November 28, 2022

Subject: Foster City Elementary School HVAC Replacement
San Mateo - Foster City School District
Aedis Project No. 2021011.05
DSA Application #01-120182

ADDENDUM NO. 1

1 NEW FIRST FLOOR PLAN - BLDG B
E3.1 SCALE: 1/8" = 1'-0"

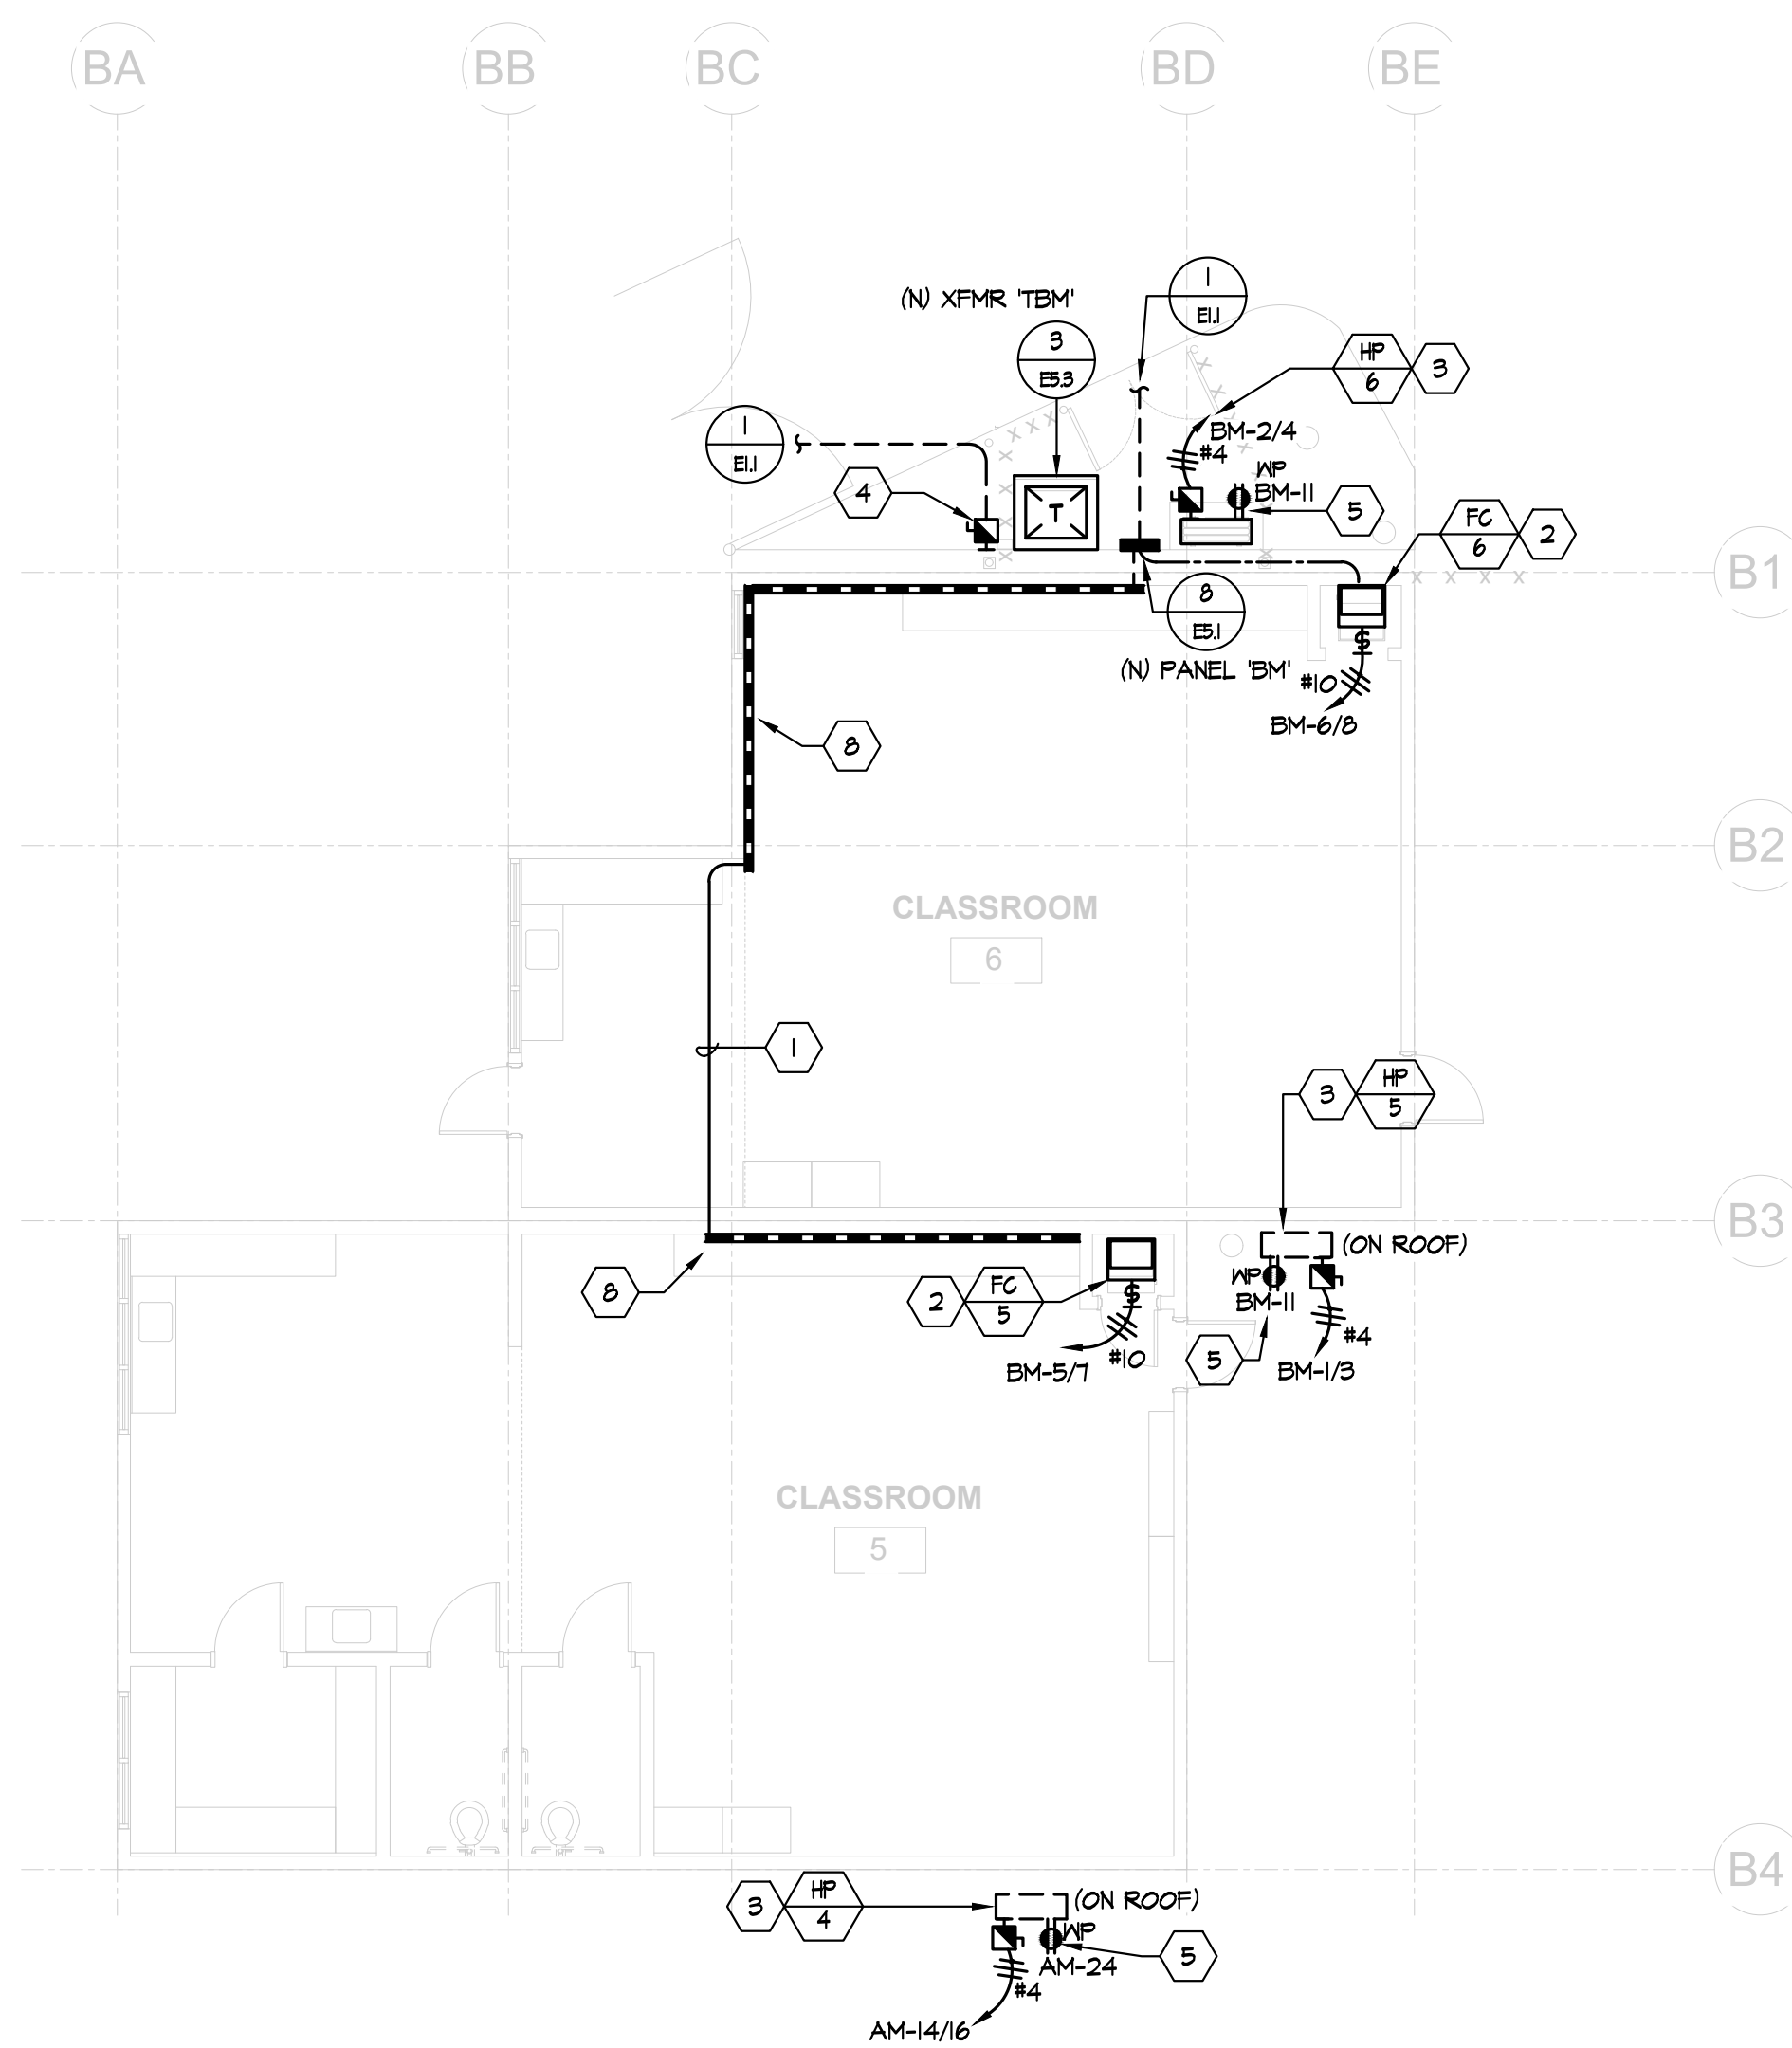
ITEM NO. 1.6: DRAWING SHEET E3.1 – NEW FLOOR PLANS – BLDG A, B, C & D

Revise: Sheet Note #4 per AD1-E3.1.

Revise: Unreadable text to make text legible per AD1-E3.1.
